July 2, 2010

Re: **CAP Addendum and Work Plan Modification**  
**Sheetz Store #177**  
**3281 Main Street**  
**Manchester, Maryland**  
**MDE Case # 06-0056CL**  
**MDE Facility ID No. 6297**

#### **CAP Addendum Modification**

**II-1**

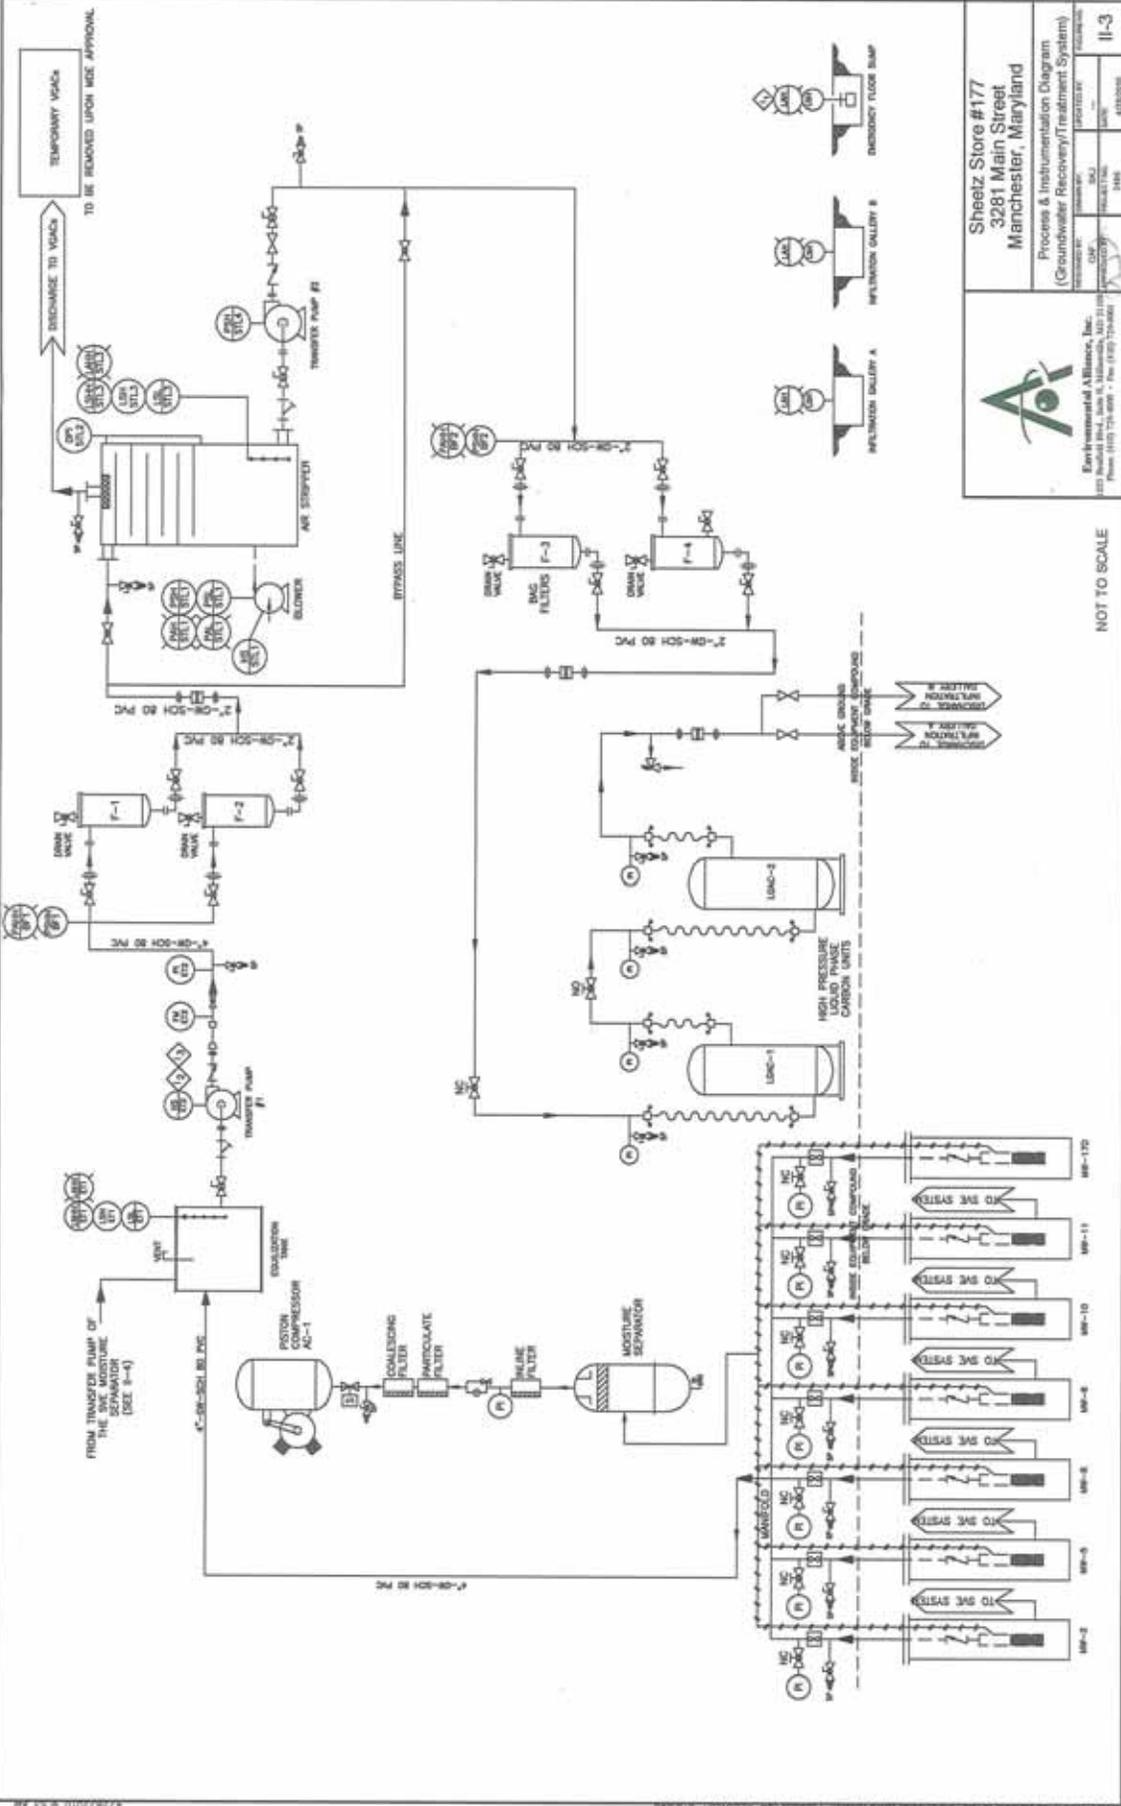
Based on this information, assuming 12 gallons per minute which equals 17,280 per day (gal/d) of discharge, and using a hydraulic rate of 3.74 gal/d/ft<sup>2</sup>, the infiltration gallery should consist of at least 4,620 ft<sup>2</sup> of space. Based on the Sheetz rebuilding design, two 80 x 30 x 7 feet deep with approximately 4,800 ft<sup>2</sup> will handle the design flow rate with a 50 percent design loading rate. The proposed infiltration gallery consists of two 80 feet by 30 feet by 7 feet trenches set at least 20 feet apart.

Another modification to the design is the addition of three monitoring points around the infiltration gallery to monitor the groundwater levels. The modified design drawings for the infiltration gallery are presented as Attachment II.
